MEMORANDUM

DATE: 11 March 2025
TO: Northern Beaches Development Determination Panel
CC: Steven Findlay, Manager, Development Assessments
FROM: Ben Tesoriero, Planning Consultant
SUBJECT: REV2024/0031 – 179 Riverview Road, Avalon Beach

Figure 1 Proposed Long Section A-A for REV2024/0031. Building shown not to contravene the 10m standard in this location. Source: Madeleine Blanchfield Architects, December 2024.

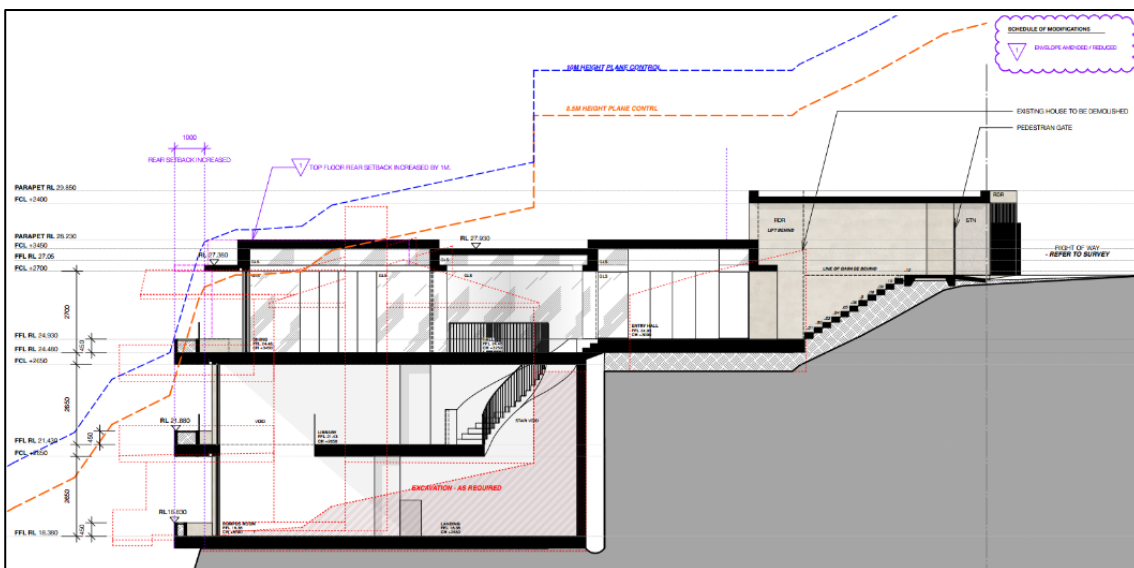
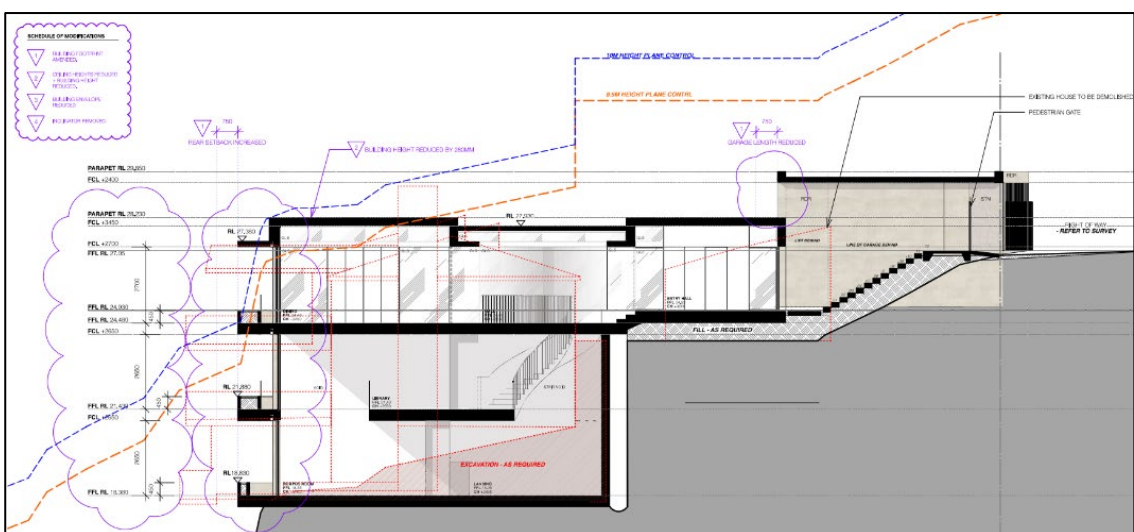
The difference between the building design refused by the DDP on 25 September 2024 because of the inability to comply with the building envelope control and that currently proposal under REV2024/0031 are marginal.

These differences are shown in Figure 19 and Figure 20 in the Assessment Report and are reproduced below for convenience.

In my opinion, the 1m setback provided to the third storey on the western elevation does little to ameliorate the three-storey vertical presentation of the building in this location.

Figure 3 Extract of the third storey floor plan showing the extend of the building setback less than 1m from the northern boundary. At the eastern edge, the balcony is only setback 600mm from the boundary. This setback noncompliance is replicated on the second storey below.

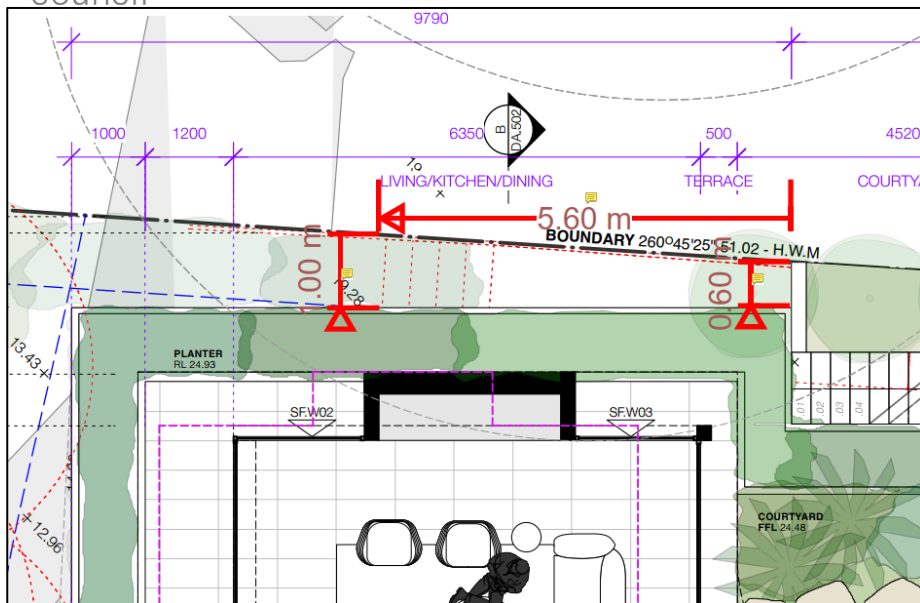
While WF characterises the northern side setback variation as minor, this is not accepted. The building encroaches upon the 1-meter setback by 5.6 meters at both the second and third storeys, resulting in a minimum setback of 600mm as shown in Figure 30 of the Assessment Report - reproduced below for convenience.

WF's assertion that the non-compliant elements are minor is inaccurate and disregards the potential BCA/NCC implications arising from a dwelling's proximity to the boundary.

While it is acknowledged that the northern property is currently less developed compared to neighbouring properties, this does not justify encroachment on the boundary setback. The potential for future development on 181 Riverview Road exists, and the proposed development's encroachment unreasonably borrows from the neighbouring property's future development potential.

The non-compliant setback on the subject site will impose a design constraint on any future development at 181 Riverview Road.

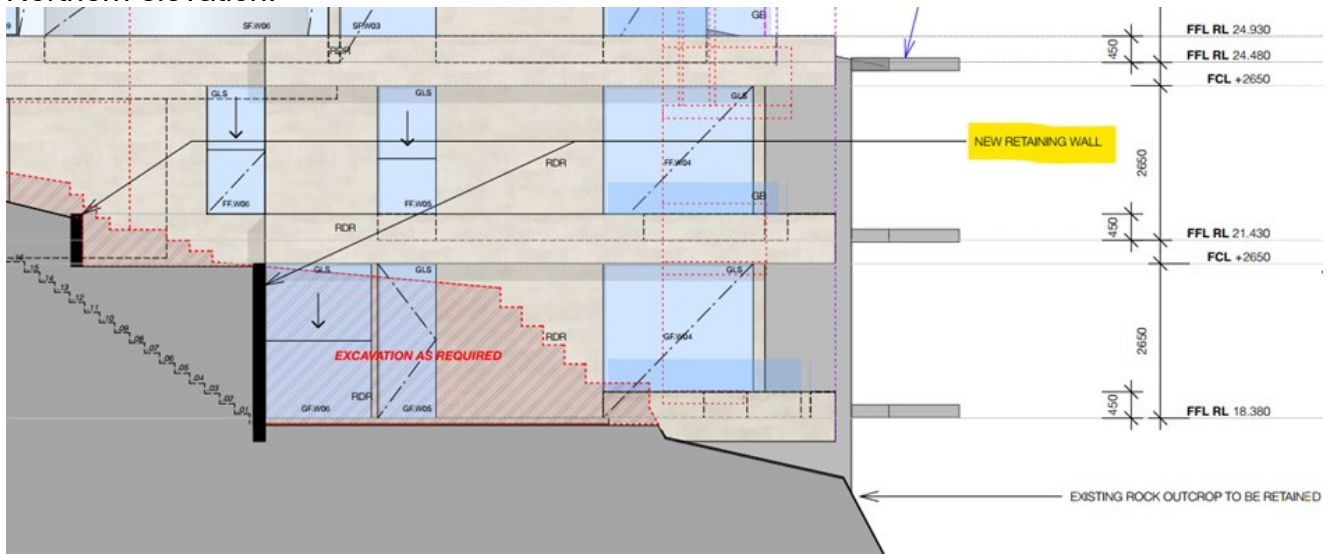
On the southern side, despite the 2.5-meter setback requirement, significant encroachments occur. Protruding floors and planter boxes, as well as the externally located lift, reduce the setback to within 1 meter of the boundary. These encroachments are a result of specific design choices and could be avoided through alternative design solutions, such as internalising the lift and reducing the extent of the protruding floors and planter boxes toward boundary.

The combined encroachments on both the northern and southern side setbacks contribute to the building's excessive bulk and scale. These, in conjunction with the building envelope and height contraventions, constitute substantial grounds for refusal of REV2024/0031.

Northern elevation:

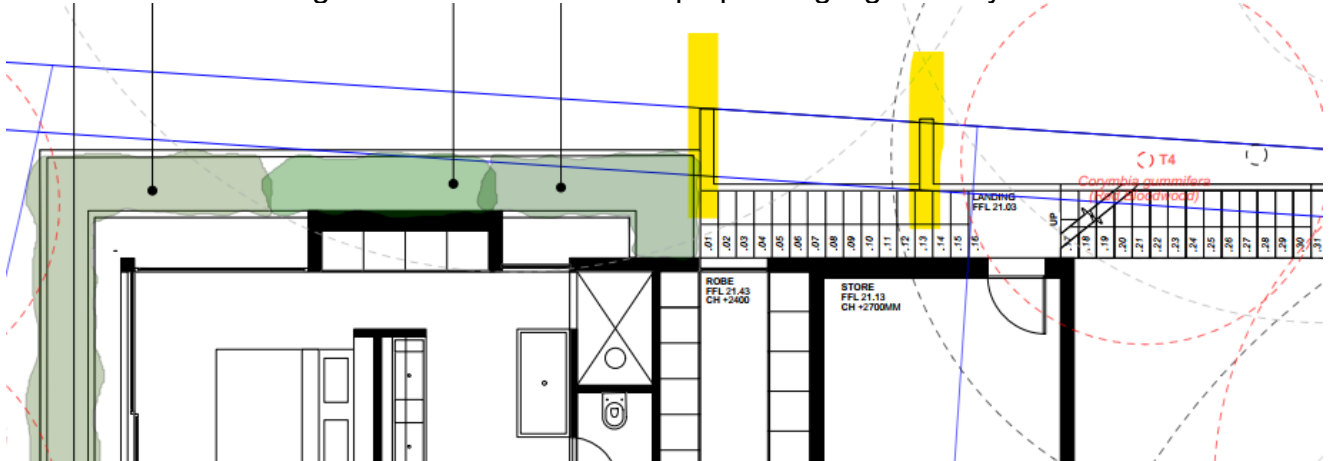
WF asserts that no retaining walls will be constructed along the northern boundary. However, this statement contradicts the submitted plans. The following excerpt from the northern elevation clearly depicts proposed retaining walls (highlighted in yellow) and significant excavation (marked in red) between the proposed dwelling and the boundary.

This excavation necessitates retaining walls not only across the site but also along the boundary. The submitted documentation fails to demonstrate how these retaining walls will be implemented and, critically, how a satisfactory cross-boundary relationship with the neighbouring property will be achieved.

Southern elevation:

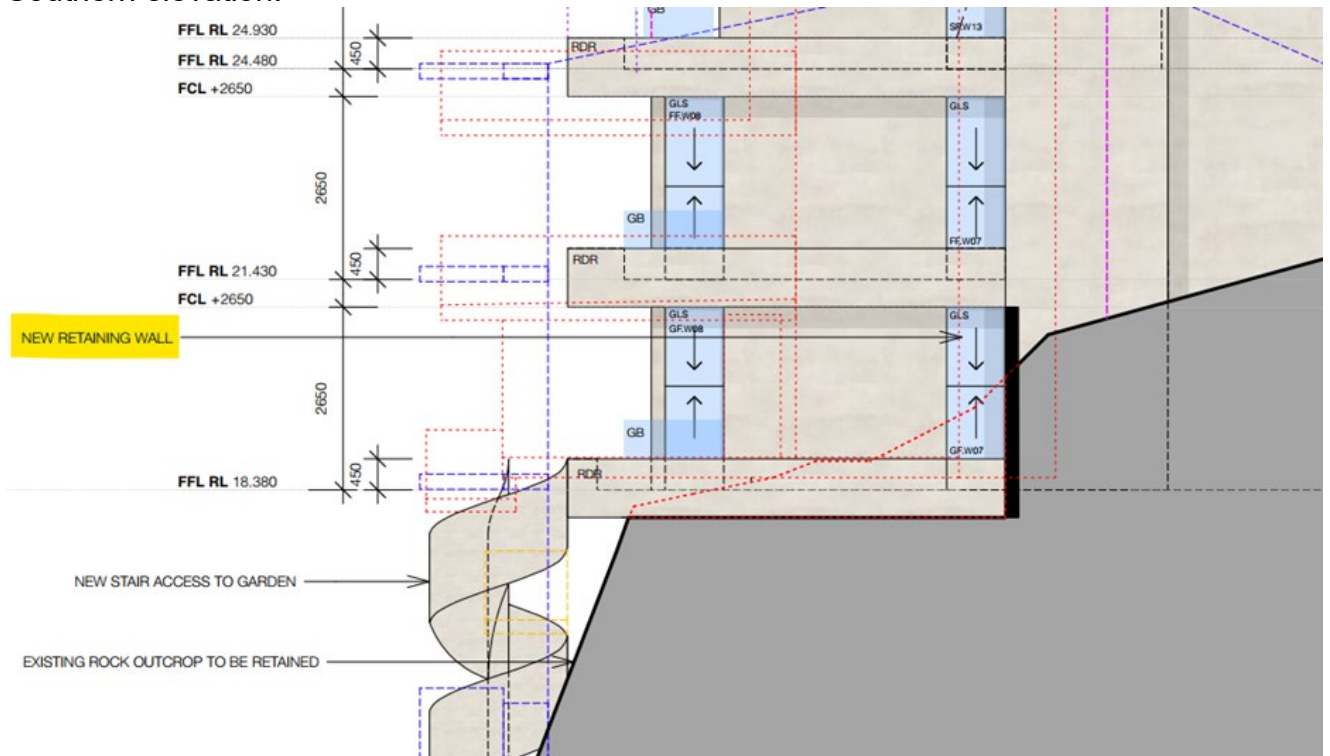
Below is an extract of the southern elevation which also shows the new retaining wall proposed. The existing ground line is shown in red, however there is no demonstration of how the excavated area will be retaining along the southern boundary.

Southern side retaining walls shown on landscape plan:

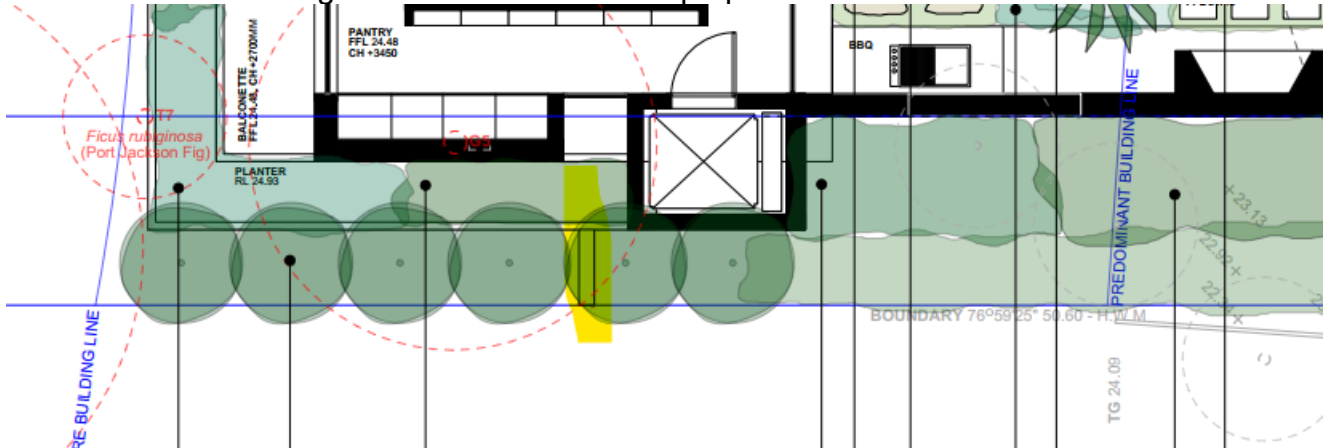
The Assessment Report highlighted the omission of side boundary retaining wall details from the stormwater plans, despite their inclusion in the architectural plans and landscape plans. This discrepancy raises concerns regarding the viability of the proposed stormwater concept. WF's submission provides no response to this point
